Service Bulletin

Model : Saddle Finisher-C2

No.: Acc-145
(FF-T01-W-000041-01)

Subject : ADDITIONAL DESCRIPTIONS

Figure 1

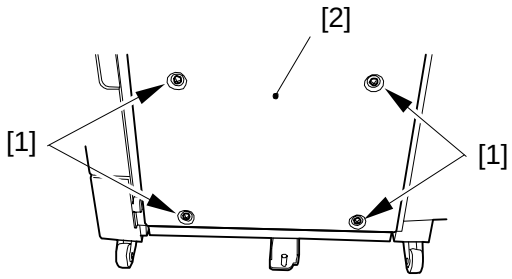
1) Remove the four screws [1], and detach the PCB cover [2].

Figure 2

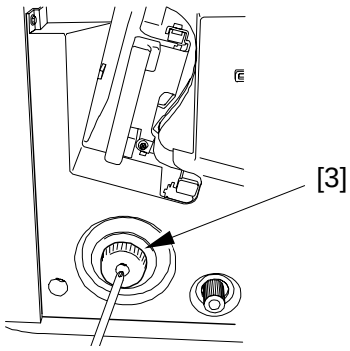
2) Remove the screw, and detach the bending roller knob [3].

Figure 3

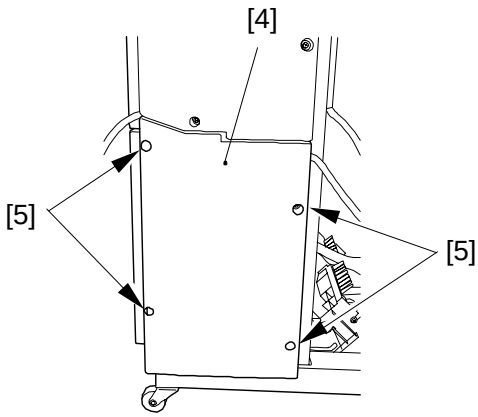
3) Remove the four screws [5], and detach the rear lower cover [4].

Figure 4

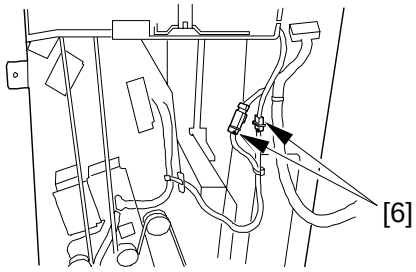
4) Disconnect the two connectors [6] used to connect to the finisher assembly.

Figure 5

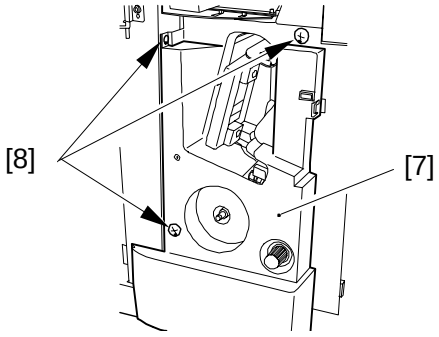
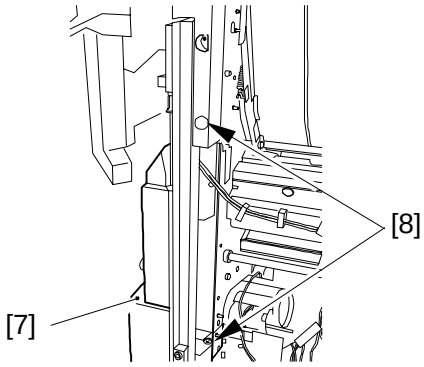
5) Remove the five screws [8], and detach the front inside cover [7].

Figure 7

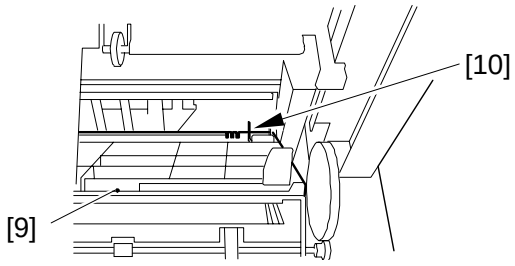
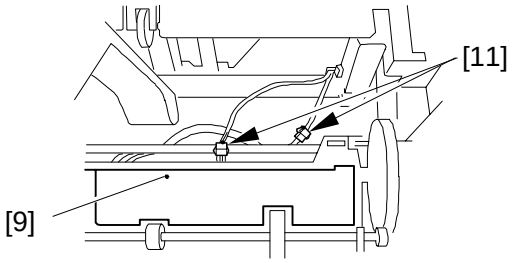
6) Remove the L-shaped pin [10], and disconnect the two connectors [11]; then, detach the delivery cover [9].

Figure 9

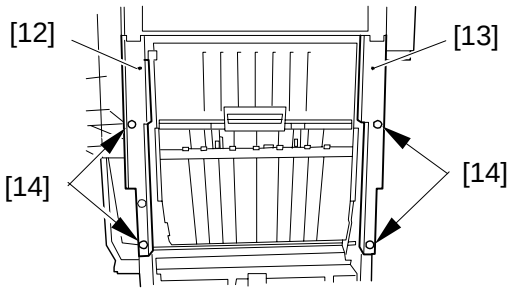
7) Remove the two screws each [14]; then, detach the front side cover [12] and the rear side cover [13].

Figure 10

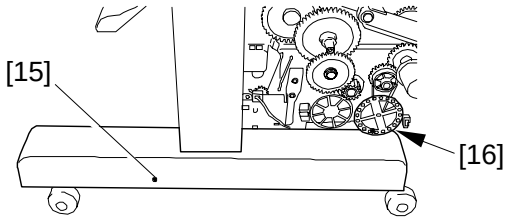
8) Remove the foot cover [15] of the frame. This is to avoid interference between the foot cover and the clock disk [16] of the paper retaining plate motor while the saddle unit is being removed.

Figure 11

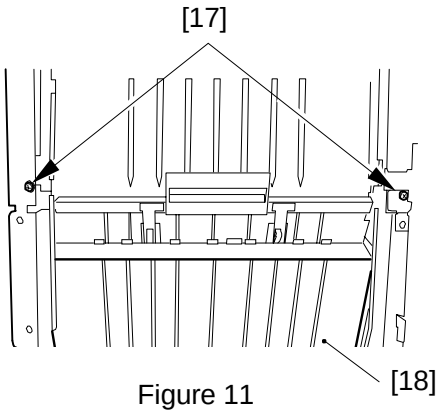
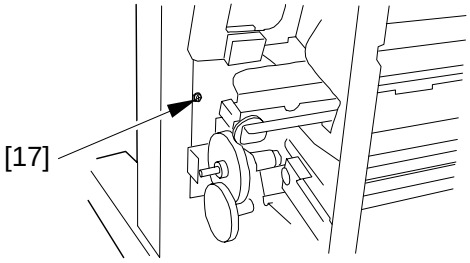
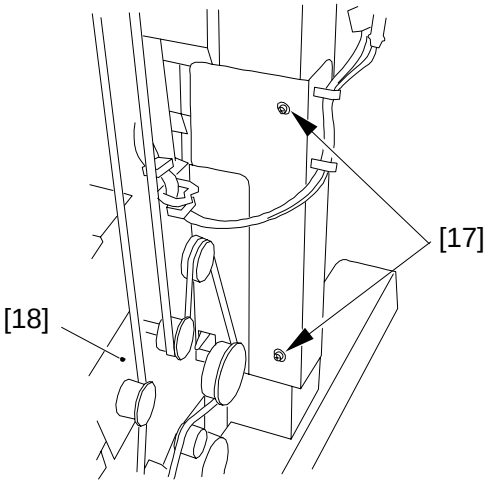
9) Remove the five screws [17] used to secure the saddle unit in place to the frame.
10) Remove the saddle unit [18] by shifting it in the direction of the copier.
